GRADING DETAILS SHEET

EXTENDED DETENTION BASIN AS-BUILT
 DANE FRANK, TERRA NOVA ENGINEERING, 2025/03/13

COUNTY PRJ #: PPR-20-020
 EPC 11/29/21

OUTLET STRUCTURE NOT TO SCALE

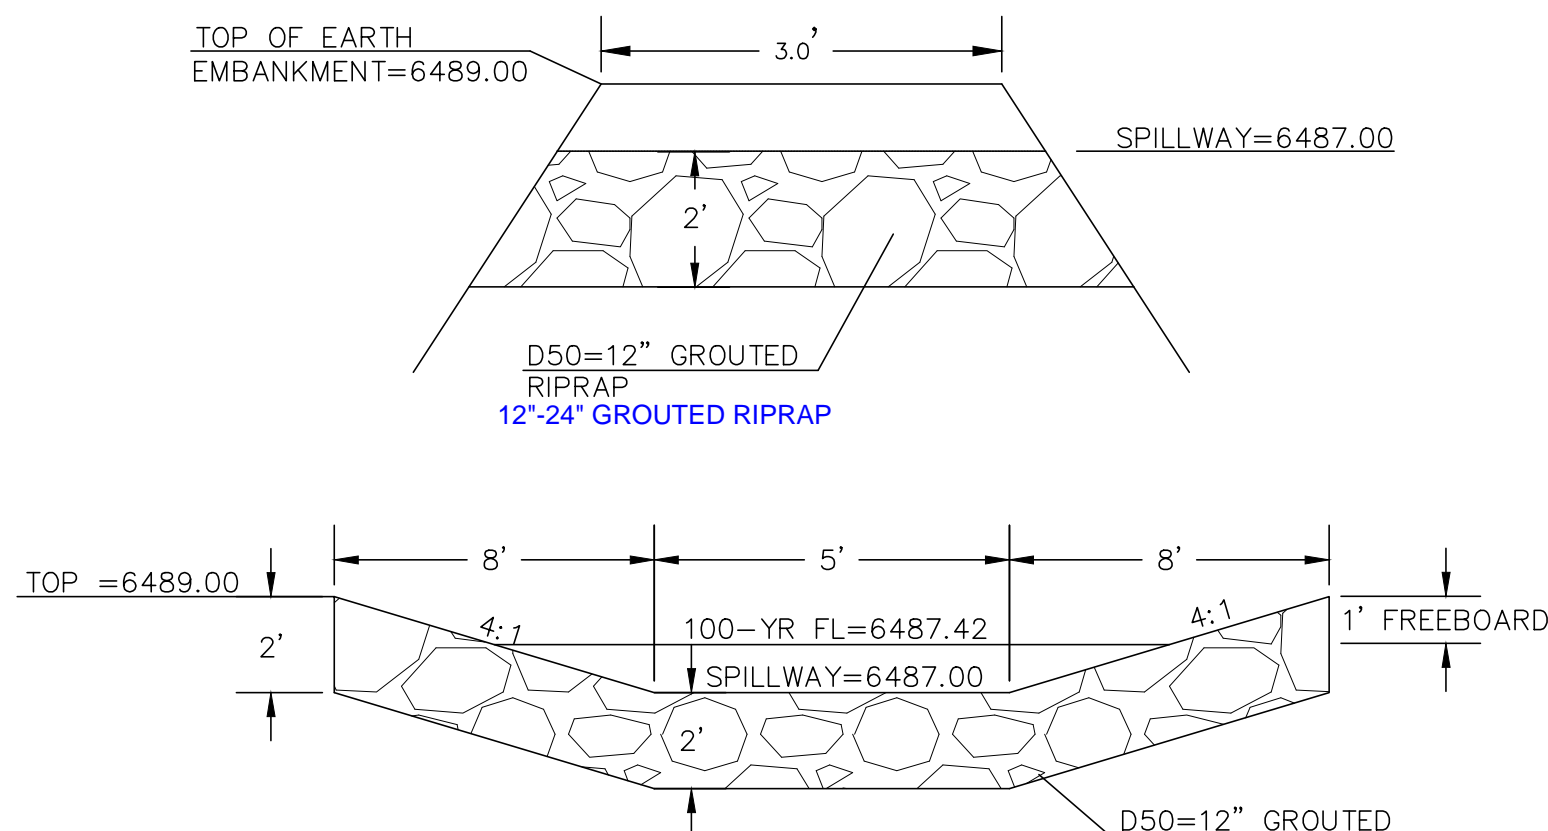
- AS-BUILT REDLINES ARE SHOWN IN BLUE.
- THE FINAL GRADING WAS A LITTLE DIFFERENT THAN THE DESIGN, AND THE TOP OF THE OUTLET STRUCTURE WAS BUILT 6" HIGH. CHECKING THE AS-BUILT NUMBERS WITH THE DESIGN SPREADSHEET SHOWS THE GRADING AND OUTLET STRUCTURE TOP WILL FUNCTION AS INTENDED, WITH THE WATER SURFACE ELEVATIONS CHANGING A LITTLE.

INLET ORIFICE PLATE PERFORATED HOLE PATTERN NOT TO SCALE. THIS DETAIL IS FROM THE REV 1 PLANS

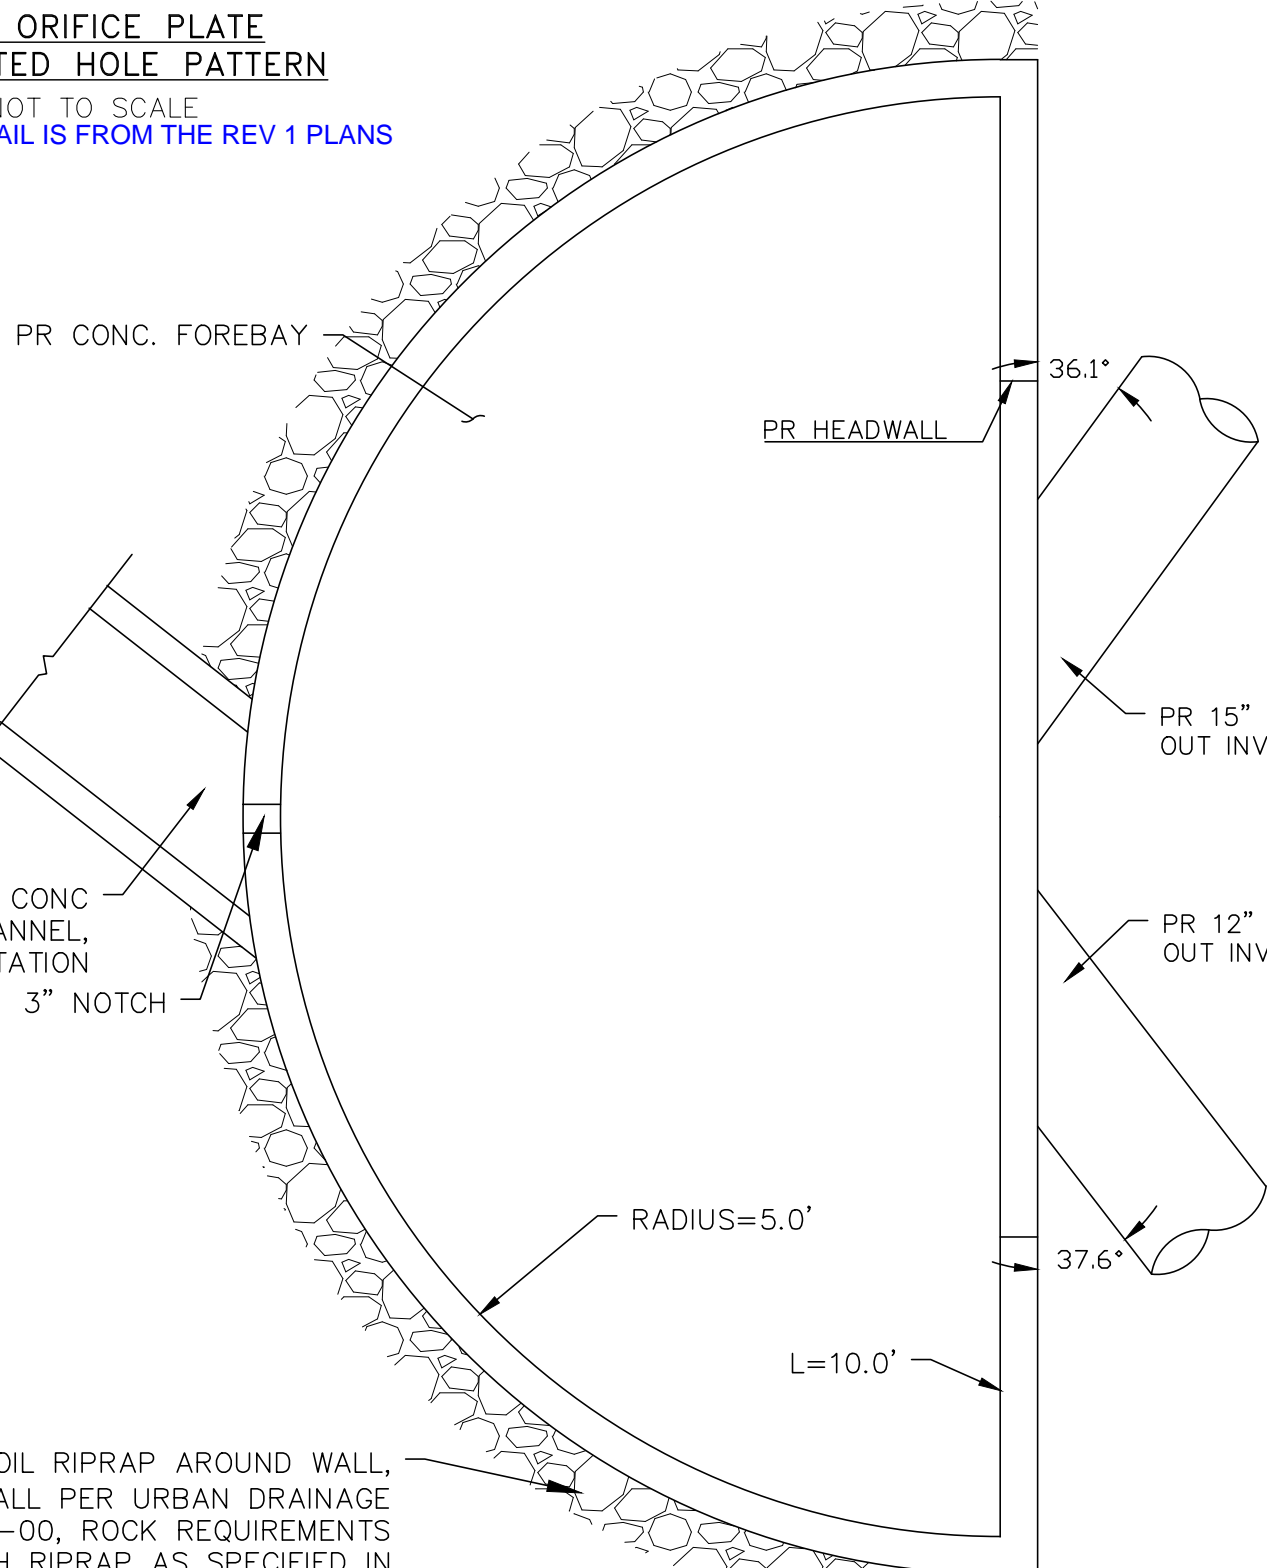
- THE BOTTOM ORIFICE ON THE INLET ORIFICE PLATE IS BUILT 0.2' HIGH. THE TOP TWO ORIFICES HAD TO BE REDRILLED AND THE CONTRACTOR LEFT THE BOTTOM ORIFICE HIGH DUE TO THE DESIGN ELEVATION HAVING TO GO THROUGH THE CONCRETE AND STEEL OF THE OUTLET STRUCTURE. THE BOTTOM ORIFICE WAS UPSIZED TO ADJUST FLOW FOR THE HIGHER ELEVATION. THE DESIGN SPREADSHEET SHOWS THIS ORIFICE LAYOUT CAUSES THE DRAIN TIMES TO BE: WQCV 40 HOURS, EURV 74 HOURS, 2 YEAR 64 HOURS, 5 YEAR 72 HOURS, 10 YEAR 77 HOURS, 25 YEAR 80 HOURS, 50 YEAR 79 HOURS, 100 YEAR 78 HOURS, AND 500 YEAR 77 HOURS. THE POND IS SHOWN TO STILL HAVE ADEQUATE STORAGE CAPACITY AND FREEBOARD IN THIS CONDITION.
